BEHDZI' AHDA FIRST NATION
P.O. Box 53, Colville Lake, N.T. X0E 1L0
Ph: (867)709-2200 FAX: (867)709-2202

This letter provides Proponent Responses regarding the **Draft Municipal Water Licence** for the Community of Colville Lake, Sahtu Region, Northwest Territories. As you know, the Behdzi Ahda First Nation's (BAFN) approach to water treatment of withdrawn Colville Lake water is currently in-truck chlorination (with circulating pump) followed by home delivery which will continue until replacement of the water treatment system. The following sections provide BAFN's Draft Water Licence (WL) responses.

TITLE:
Sewage Lagoon

Attachment: Revised Figure 4, Appendix 1 (WL Application Package)

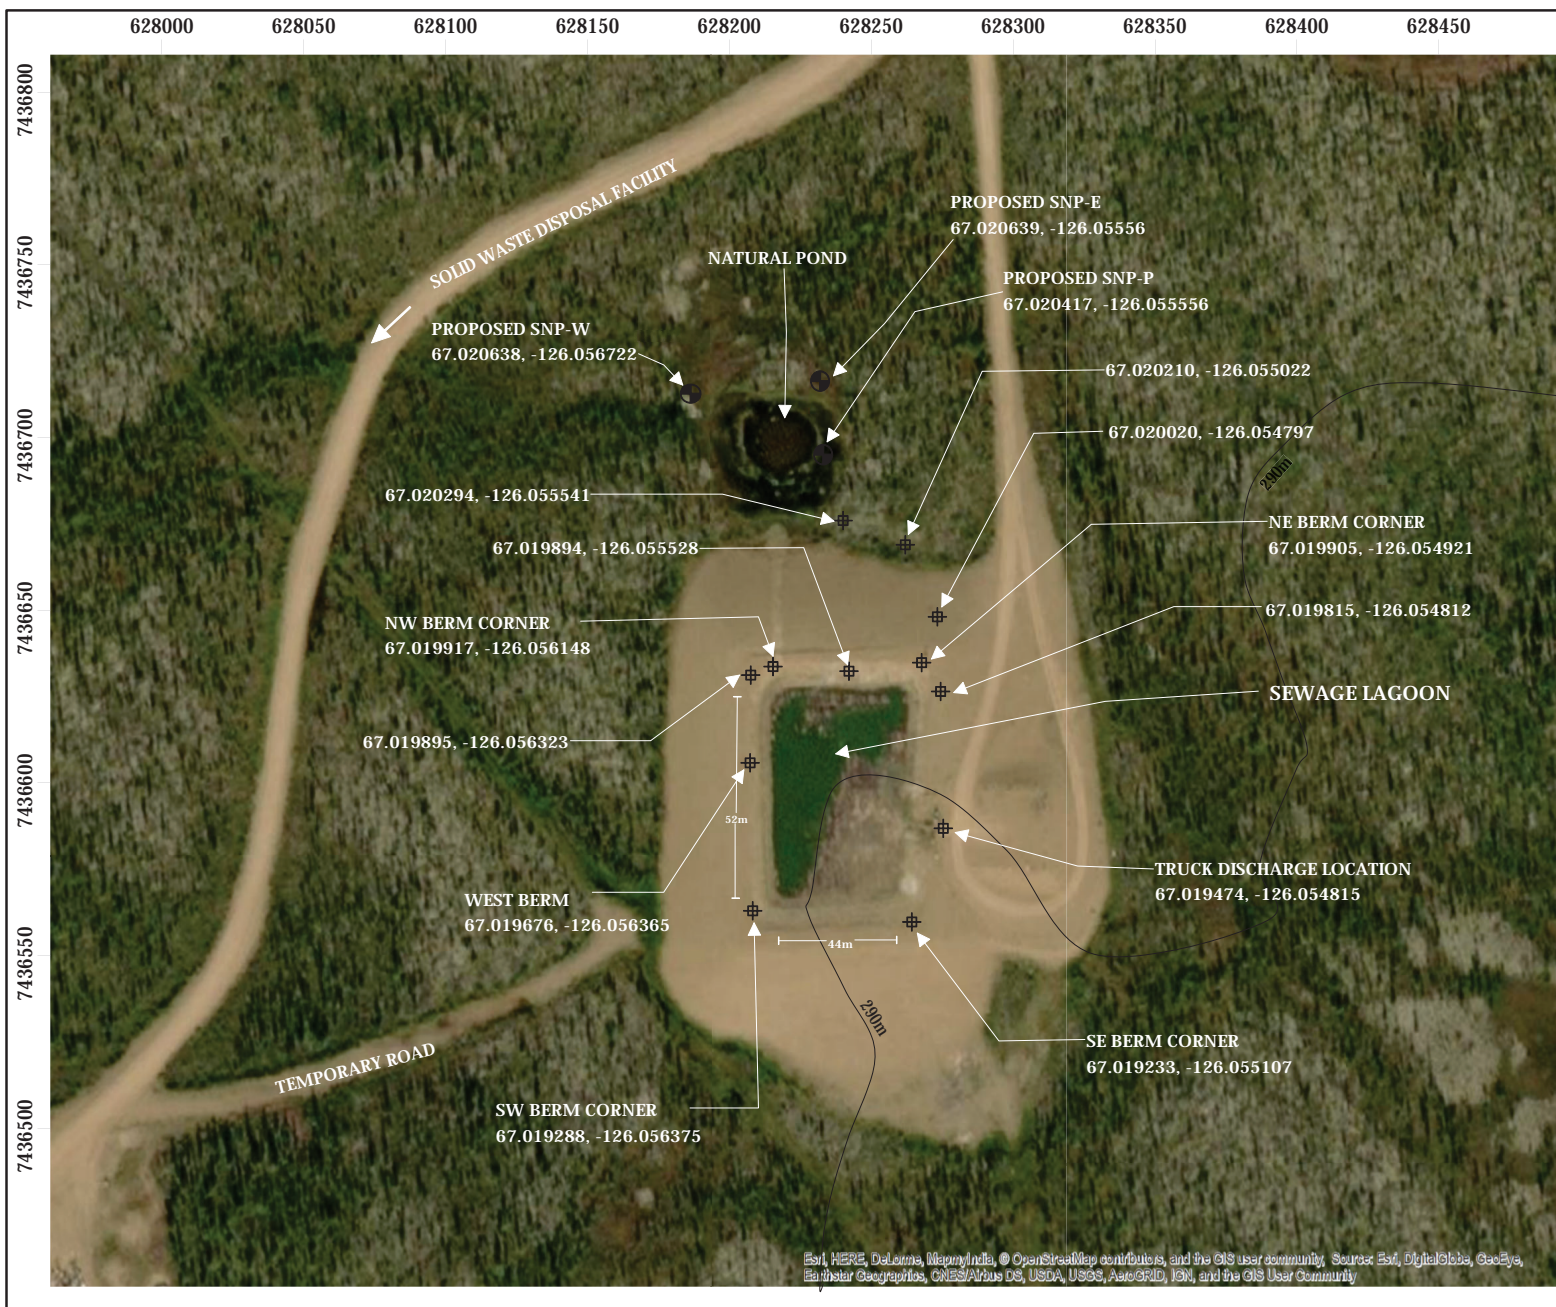
4. Draft Page 18, Schedule 1: Surveillance Network Program, #4, SNP – E, C, W and SLWB Comment - BAFN Input requested to 1) convert proposed groundwater monitoring stations to surface water monitoring stations and 2) move at least 2 locations closer to the adjacent water body.

BAFN is agreeable to have proposed SNP locations SNP-E and W converted from groundwater to surface water sampling and moved closer to the natural pond as shown on revised Figure 4, Appendix 1 (Attached). It is thought that sufficient surface water will be present during open water season. Rather than sampling groundwater at SNP-C, surface water pond sampling is proposed instead at location SNP-P, obtaining grab samples from shore with extension pole/litre lab bottle collection.
